AERONAUTICAL CHARTING MEETING Charting Group Meeting 23-02 – October 24-26, 2023

RECOMMENDATION DOCUMENT

FAA Control #23-02-380

<u>Subject</u>: Modification of contour depictions on Instrument Approach Procedures (IAP) charts

Example of current depiction of contours on MSO RNAV (RNP) Rwy 30:

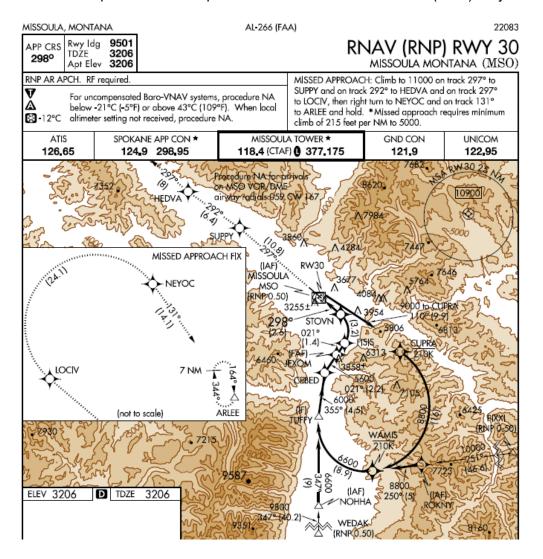
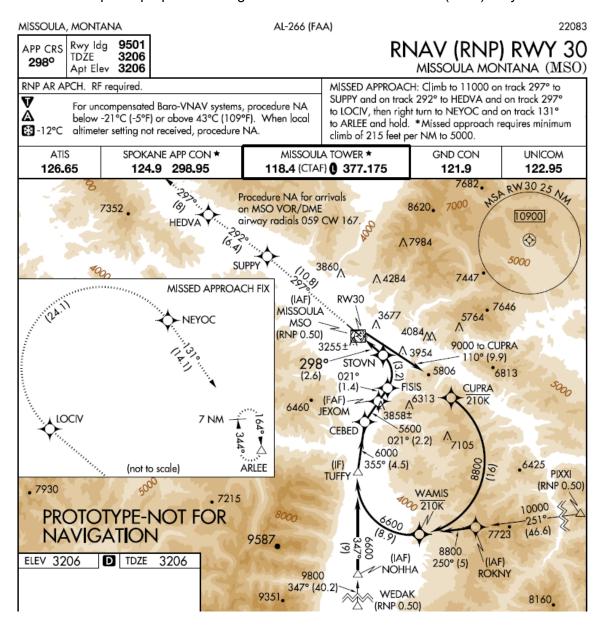
Terminal Charting would like to propose a change to the depiction of contours on IAP charts. As charts become more complex, the current depictions of contours on IAP charts, especially ones that are heavily congested, introduce clutter that obstructs procedural data and makes the charts difficult to read and understand.

On IAP charts that require terrain, Terminal Charting proposes the removal of the contour interval lines to enhance the readability of the chart while preserving the contour intervals themselves.

Rich Boll, NBAA, thanked Krystle for bringing this recommendation and said he strongly agrees with this change. He pointed out that in the MSO example, it is almost impossible to read the procedural information on the chart, especially in low lights in the cockpit. He said he hopes Jeppesen will also make this change on their charts. Rich asked if charting had looked at the prototype charts in the various digital displays. He said they do not look the same when they are on paper as they do on digital displays in the airplane. Krystle said they have not investigated how the contours look on the digital displays.

Example of proposed changes to contours on MSO RNAV (RNP) Rwy 30:

More examples of targeted cluttered areas:

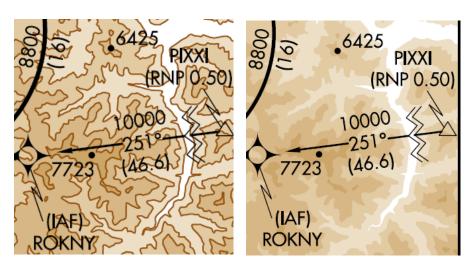
On some of the examples above, it is very difficult to even read the names of fixes or discern the routes on the current charts. Not having the interval lines depicted makes it significantly clearer to read the same information.
